## Leeds' plan for flood easing from Apperley Bridge to Calverley

Comments by Onno Bokhove

### *Regarding Leeds' flood-mitigation plans for Apperley Bridge, Bradford*

Figure 1: Graph relating to point a) above. Natural green berm/dike instead of industrial steel-sheet pile wall. Similar to a drawing in [1], along Apperley Road. Black arrows, larger text and cross-section of new berm against existing wall (upper-left) added by OB.

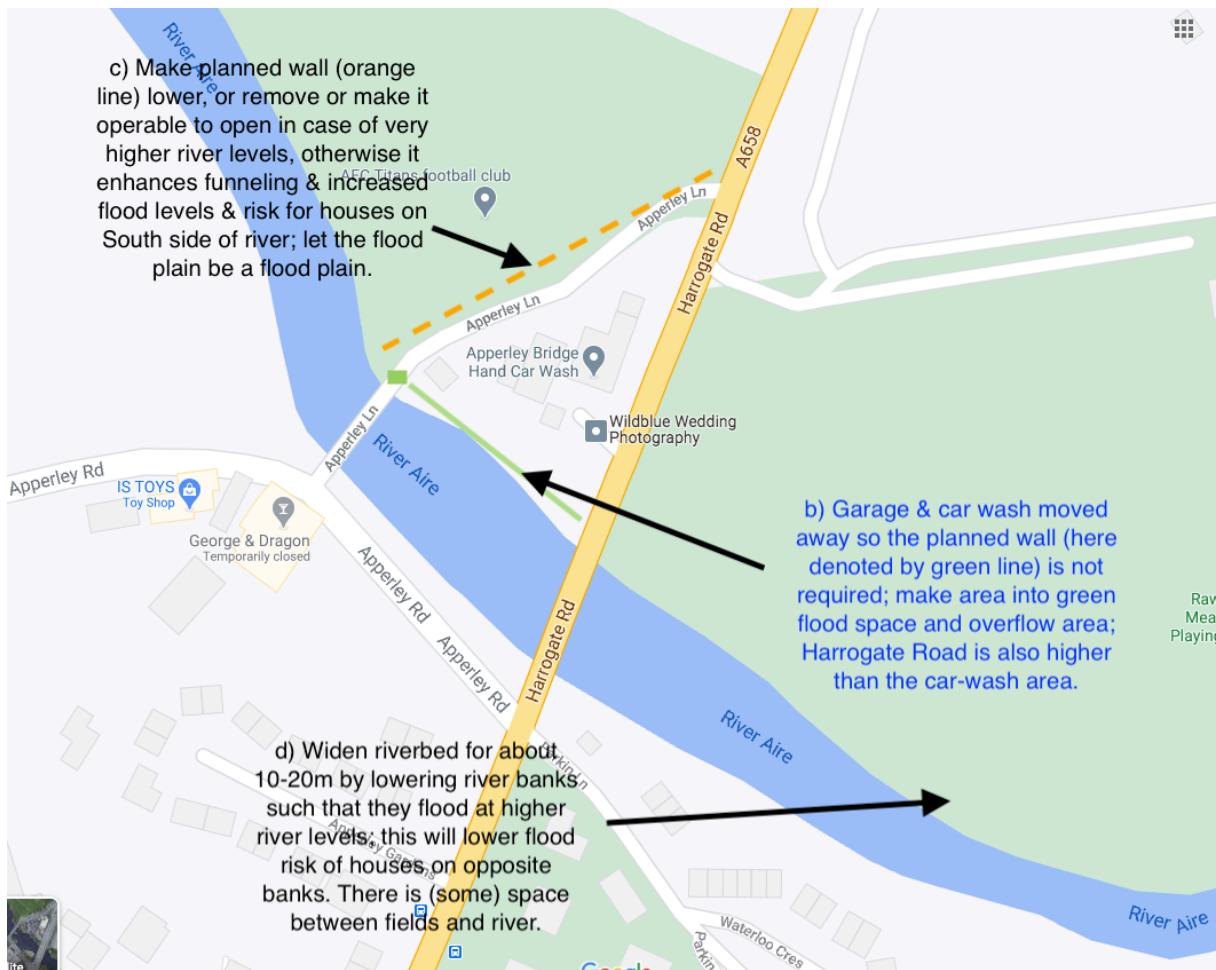
- a) ***An alternative, possibly cheaper and certainly greener, solution to the steel-sheet pile wall*** on the South side of the river along the minor road to Apperley Bridge (see drawings in [1] and Fig. 1) is a berm formed by clay/soil with grass on top, e.g., clay/soil from the in-situ flood plain, which would result in a zero-or-negative volume change, concomitantly creating more-or-zero change in floodplain-storage capacity. This would be an example of a green *Nature Based Solution* (NBS), a berm or dike, which can fit seamlessly and naturally to the existing stone wall (with repairs of that wall where necessary) along Apperley Road. See also Fig.1.

***Question 1: How does the steel-sheet pile wall look (there is no image); what are its costs relative to green dikes/berms, in terms of construction and maintenance?***

Figure 2: Remarks with locations indicated relating to points b), c) and d) above. Similar to a subsection of a drawing in [1], along the River Aire in Aupperley Bridge. Fat arrows and black/blue text added by OB. (Grid reference: SE 19475 37978)

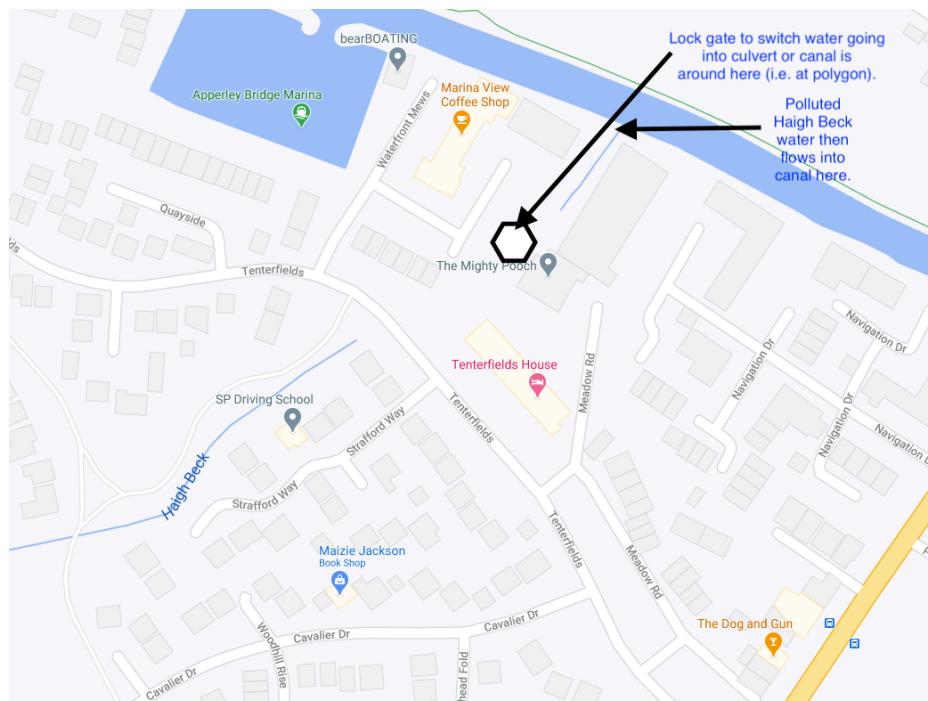
- b) There is a steel-sheet pile wall planned along the North side of and directly along the river to protect the garage (see drawings on [1] and Fig. 2). ***The garage and car wash, however, have recently moved.*** Both garage and car wash are/were polluting the river. The area can be, with the soil cleaned, lowered and made into green space; the river bank there can also be widened and lowered in places, thus giving more room to the river and better preventing floods on the built-up South side because the water can go somewhere (i.e. it can flow onto the floodplain as intended by nature). Hence there seems to be no need for this steel-sheet

- pile wall on the North side along the river between the two bridges. See also Fig. 2. The steel-sheet pile wall connects the two bridges but note that the bigger bridge has open sides and that the garage land and road off the small bridge are lower lying; the bigger road lies higher; hence, there is no need for this wall in order to protect the bigger road. See also the connection with point c) below as well as Fig. 4.

- c) A closed steel-sheet pile wall on the North side of the river along the minor road coming off the old Apperley Bridge will lead to enhanced funneling of the river and, hence, increased river-levels which, recalling point (i) above, puts the houses on the South side at increased risk of flooding. Furthermore, under climate change such flood risk is expected to increase. Instead, these walls could be lowered, not strengthened/raised, or possibly several operable gates could be included that can be opened at very high river levels to lessen the pressure on the South bank flood-defense wall. In conjunction with b) above, flood waters can then flow over this road (in a case without wall or with a lowered wall) and the flood waters can be led away via the new lowered space between the two bridges. Cf. Akers and Bokhove 2008 [4]. See also Fig. 2.  
This entire wall can be a green berm as in point a) above, instead of a steel-sheet pile wall, which (berm) is more green, with lock gates to be opened when river levels rise too high such that the flood plain is flooded rather than the collection of houses on the South shore.

- d) Downstream of the main bridge on the North side, the football pitches are far enough from the river that it is possible to widen the flood channel somewhat, by lowering the banks ~1m-to-2m over a strip, adjacent to the river and of width ~10m, which will be dry during normal river flow but covered with river water and creating more through-flow at lower river levels when the river level rises, see Fig. 2. This is an example of modern giving-room-to-the-river (GRR) flood-mitigation practice and Nature Based Solutions (NBS) [2].

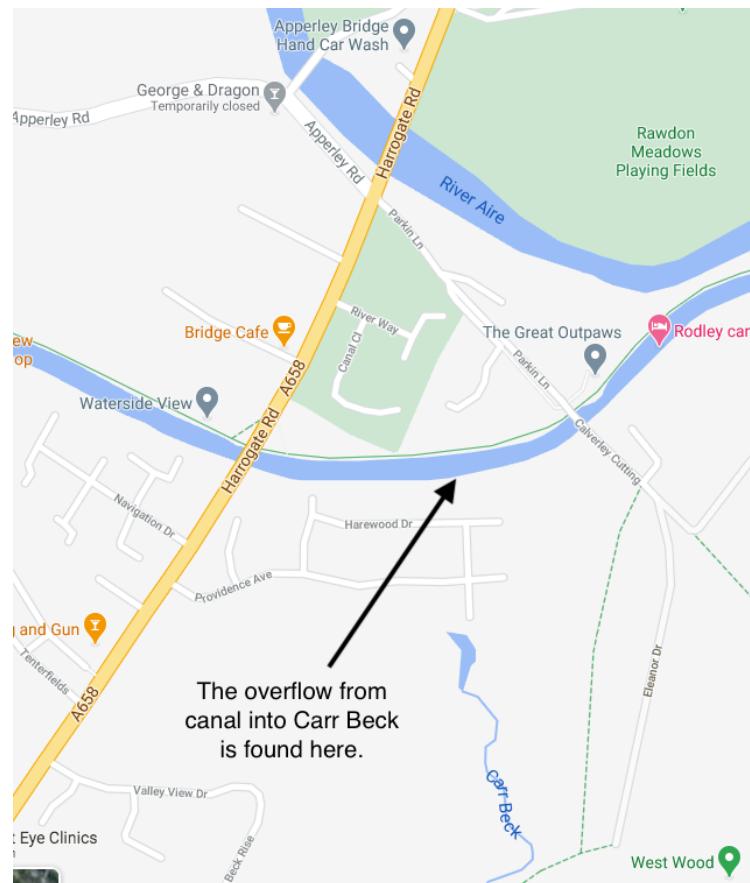
- f) The water from Haigh Beck, the beck flowing through Apperley Bridge just North of the canal, once cleaned (of the substantial accumulation of pollution by pieces of industrial cloth, etc.), could preferably flow into the canal and then into Carr Beck via the overflow, further along the canal, thus creating an extra buffer. By doing this, the beck water then avoids filling culverts under housing, and a more green and healthy beck has also been created.

On 06-02, OB led the EA officer, a flood victim and Yorkshire Water/West people on site to the lock gate just off Tenterfields, where the beck water on that day was divided for circa 10% into the canal and for circa 90% into the culvert towards the houses next to the river between the two bridges. Nobody had the key to the lock to control the flow or knew who had the authority to control these diversions of the beck flow. Critical issue is whether the (perhaps heavily) polluted beck waters should, in case of a flooding emergency, flood either the (cellars and gardens of) houses or the canal. The canal has an overflow into Carr Beck and the River Aire. In the 21st century the gate could be automated, with waterlevel/flow

and quality sampling, and operated with AI, including a manual override. Such remotely run water-level controls on canals are found everywhere nowadays, e.g. in The Netherlands, so there must be affordable set-ups available. See also Fig. 3.
